HISTORIC AND DESIGN REVIEW COMMISSION

HDRC CASE NO: 2015-394
ADDRESS: 609 E GUENTHER ST
LEGAL DESCRIPTION: NCB 940 BLK 3 LOT 6
ZONING: UZROW
CITY COUNCIL DIST.: 1
DISTRICT: King William Historic District
LANDMARK: Davis, Ross - House
APPLICANT: Celia Mendoza
OWNER: Camilo & Maureen Gonima
TYPE OF WORK: Final approval of partial demolition of an existing addition and new addition
REQUEST:

Historic and Design Review Commission
Design Review Committee
Report & Recommendation

REQUEST: REAR SECOND LEVEL ADDITION TO PRIMARY HISTORIC
STRUCTURE.

Proposed Roof Plan

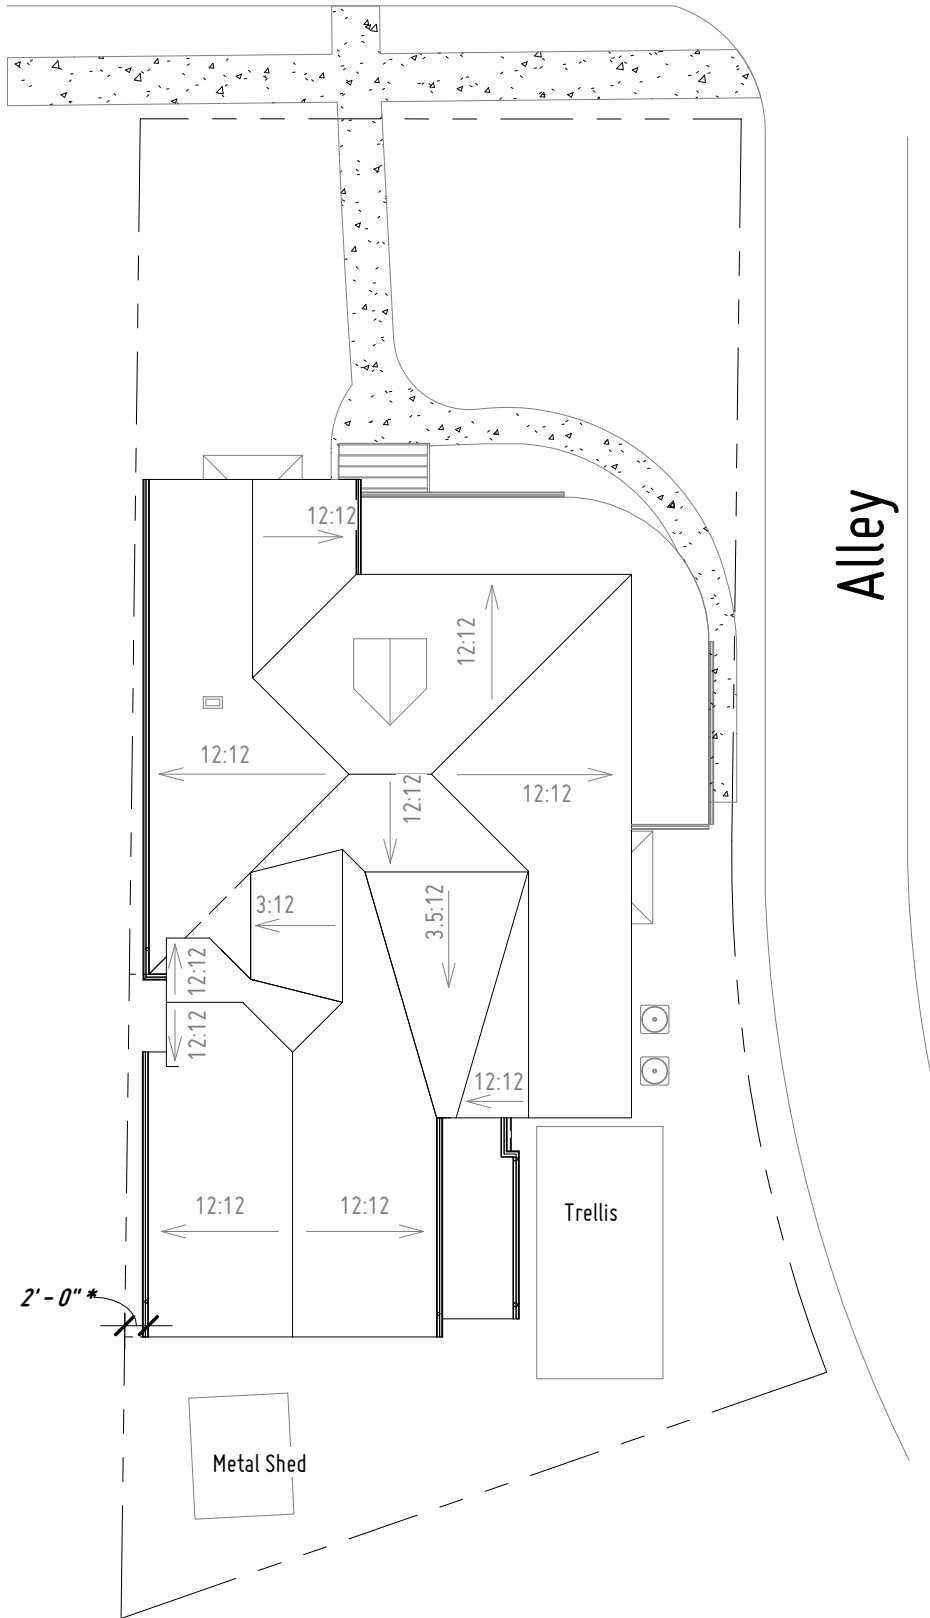
COMMENTS/CONCERNS: AL: POSSIBLE CONCERNS WITH ADDITION'S ROOF
INTERFERING WITH THE HISTORIC STRUCTURE'S ROOF. POTENTIALLY MOVE
PROPOSED DORMER TO THE REAR TO PROVIDE A CLEAR DISTINCTION
BETWEEN THE NEW AND OLD; SHOULD NOT INTERSECT HISTORIC ROOF.
DORMER AREA IS AWKWARD; VISUALLY DORMER IS OFF BALANCE.
POSSIBLE TO MIRROR DORMER'S STREET SIDE VS. REAR SIDE.

APPLICANT WAS ADVISED TO SHOW DRAINAGE DIAGRAM & TO LOOK

Proposed North Elevation

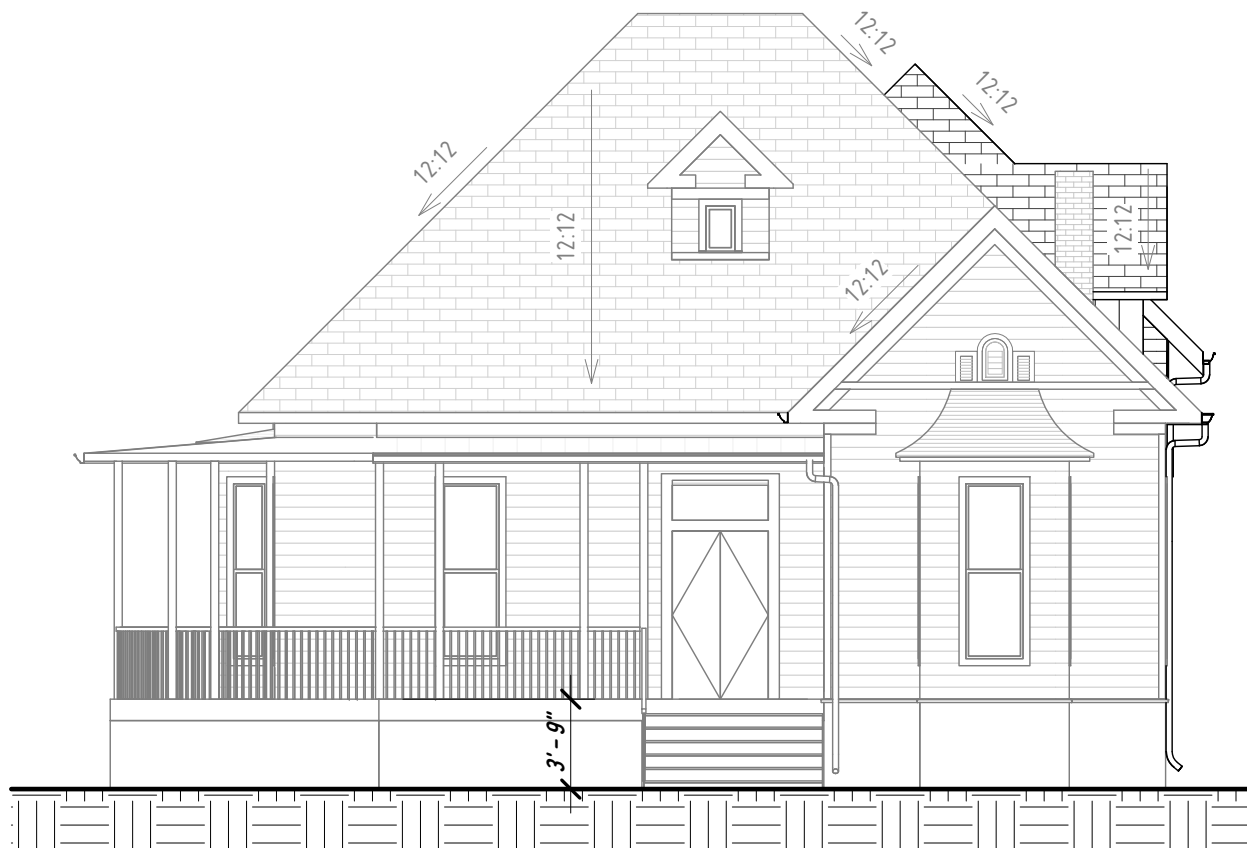
@ VIEWING NORTH FACADE @ THE DORMER
